City of Detroit  
Inter-Departmental Communication

**RE:** Petition No. 1095  
Request to Outright Vacate a Portion of Hendricks St. in the Area Bound by  
DuBois St., Hunt St., Chene St. and Vernor Highway

REQUEST TO OUTRIGHT VACATE  
 A PORTION OF HENDRICKS ST. 50 FT. WD.  
 IN THE AREA BOUND BY  
 DUBOIS, HUNT, CHENE ST.  
 AND E. VERNOR HWY.

**Detroit Water & Sewerage Department**  
**Provisions for Relocation Due to Vacation for Petition No 1095**

JOB NO. 01-01  
 DRWG. NO. X 1095

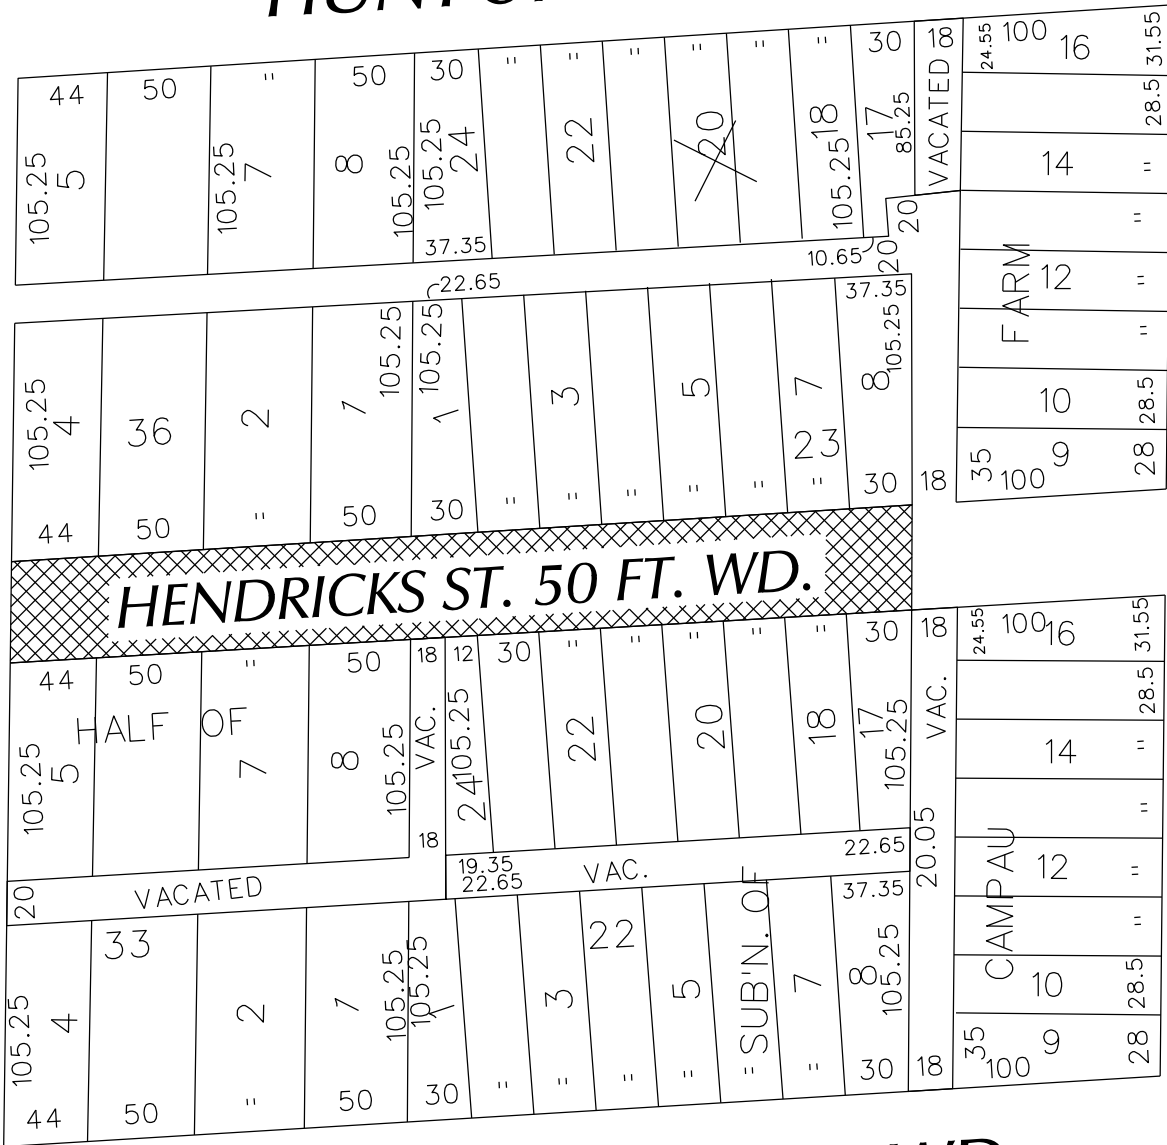
The Detroit Water and Sewerage Department (DWSD) is in receipt of the subject petition. DWSD has water and/or sewer lines located within the area requested to be outright vacated. The vacation request will be denied unless at least all the following conditions are met:

- Petitioner prepares a relocation plan for DWSD utilities, signed by a Registered Engineer
- DWSD approves the relocation plan
- Petitioner grants DWSD a satisfactory easement
- The Petitioner is to bear the entire cost of the proposed plan, including construction, demolition, permitting, inspection, survey, etc.

The entire work is to be performed in accordance with DWSD specifications and standards. Deposit with DWSD, in advance, the whole amount necessary to cover the costs of permits and inspection.

Provided that the petitioner shall design and construct proposed sewers and water mains and to make the connections to the existing public sewers and water mains as required by the Detroit Water and Sewerage Department (DWSD) prior to construction of the proposed sewers and water mains,

Provided that the plans for the sewers and water mains shall be prepared by a registered engineer; and further

Provided that the petitioner shall grant to the City a satisfactory easement for the sewers and water mains; and further
